Service Bulletin No: 76-002

Modification No: EC-09-0541

**ENGINE CONTROLS - POWER CONTROL
CHECK THE POWER CONTROL LEVER REVERSE THRUST LATCH FOR STICKING****1. Planning Information****A. Effectivity**

PC-12/47E Aircraft, MSN 1001, 1003 to 1140.

Engine Console Assembly - Removal/Installation
Figure 1

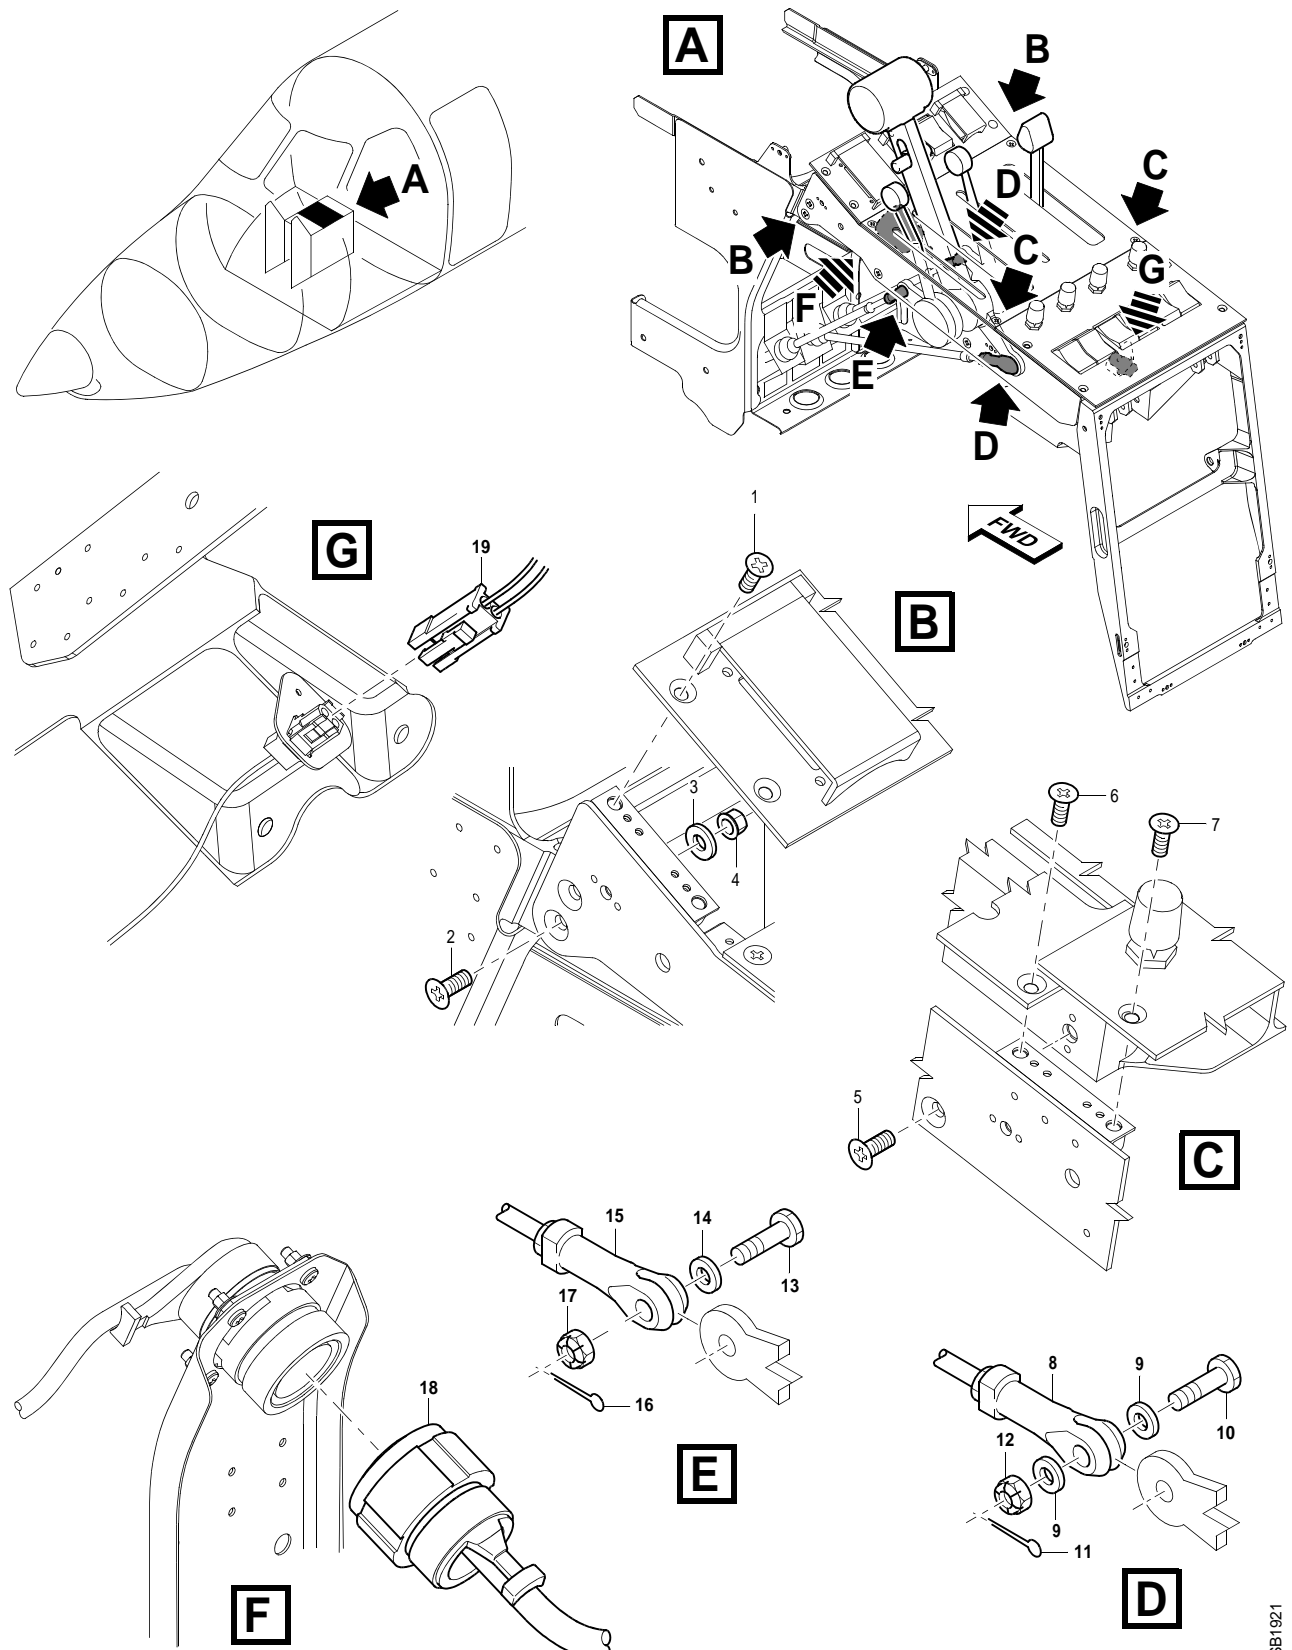
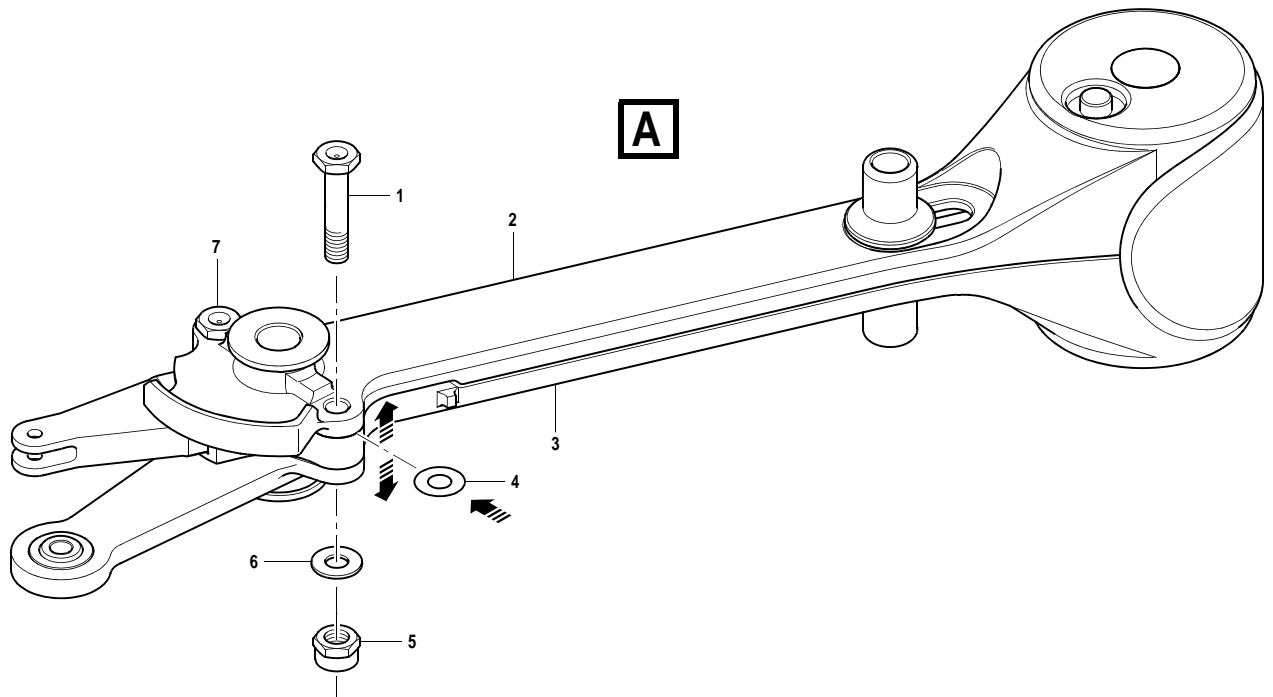
Refer to Figure 1.

Power Control Lever - Modification
Figure 2

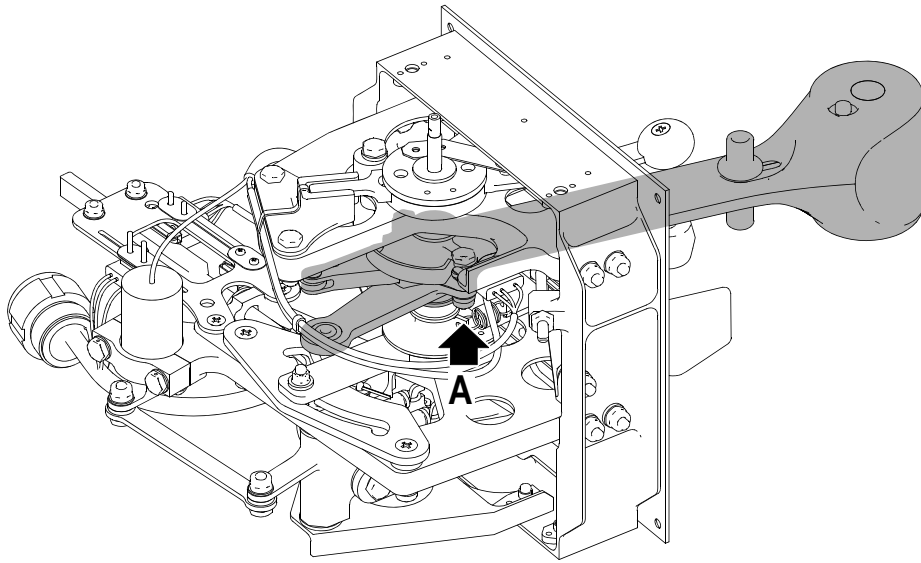
Revision 1 to this Service Bulletin corrects Figure 2 to show the correct installation of the washer in the Power Control Lever. It also adds a copyright paragraph. Customers who have already incorporated Part 2 of this Service Bulletin at initial issue must make sure that the washer is correctly installed in the Power Control Lever. This can be confirmed either by a visual inspection, or by carrying out Paragraph 3.A Part 1 again.

Refer to Figure 2.

- (a) Move the PCL to the full REVERSE position.
- (b) Make a note of the position and remove the cable tie that holds the electrical loom to the PCL.
- (c) Loosen the bolt and nut (7, Fig 2) two to three turns.
- (d) Remove the nut (5, Fig 2) and washer (6, Fig 2).
- (e) Move the bolt (1, Fig 2) out of the PCL to give access to install the washer in the next step.

- (f) Use a small plastic wedge to separate the PCL halves (2, Fig 2) and (3, Fig 2) enough to slide the new washer (4, Fig 2) (P/N 938.77.81.012) into position between the two PCL halves to engage on the bolt (1, Fig 2).

- (g) Remove the plastic wedge.
- (h) Install the bolt (1, Fig 2), washer (6, Fig 2) and nut (5, Fig 2).
- (i) Tighten the bolt and nut (7, Fig 2).
- (j) Install a cable tie (Material P09-005) to hold the electrical loom on the PCL as noted in step (b).
